## REVISED RESPONSE TO REQUEST FOR ADDITIONAL INFORMATION

### APR1400 Design Certification

Docket No. 52-046

RAI No.: 549-8856  
SRP Section: 03.12 – ASME Code Class 1, 2, and 3 Piping Systems and Piping Components and Their Associated Supports  
Application Section: 3.12  
Date of RAI Issue: 07/07/2017

**Figure 2-1. Dimensions of Discharge Tube Used in Palde's Experiment**

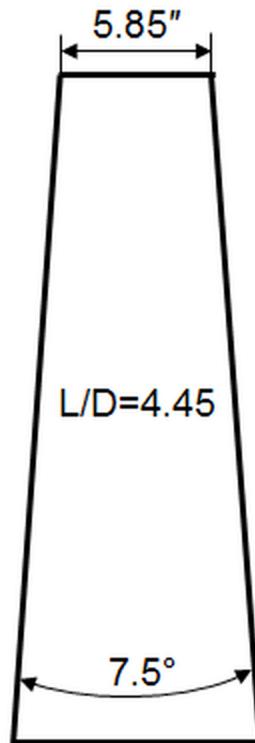
- a) The staff would like to understand whether and how cavitation effects and vibration originating from the operation of the SIT and its FD have been taken in to account in the structural design evaluation of the SIT, its discharge piping and pipe supports.
- b) Also please discuss whether the operation of the SIT with its FD can result in other phenomena, such as water hammer, and how their effects have been accounted for in the structural design of SIT, FD, piping and supports.
- c) In addition, please discuss whether the structural evaluation model of the SIT is coupled with the FD. If decoupled, please discuss how consideration for protection against resonance has been accounted for.

In order to assess the possibility of resonance caused by vortex breakdown, the CFD analysis results were compared with Palde's draft tube experiments [6]. Palde tested 75 distinct tube shapes. Most of them were simple geometrical shapes or combinations of straight circular cylinders, truncated diverging cones, and circular cross-sectional elbows. However, it is determined that there is not an identical shape corresponding to the fluidic device discharge nozzle in Palde's tests. Therefore, the most approximate shape in the Palde's tests is used to estimate the frequency parameter. Figures 2-1 to 2-3 show the dimensions of the fluidic device compared to Palde's discharge tubes.
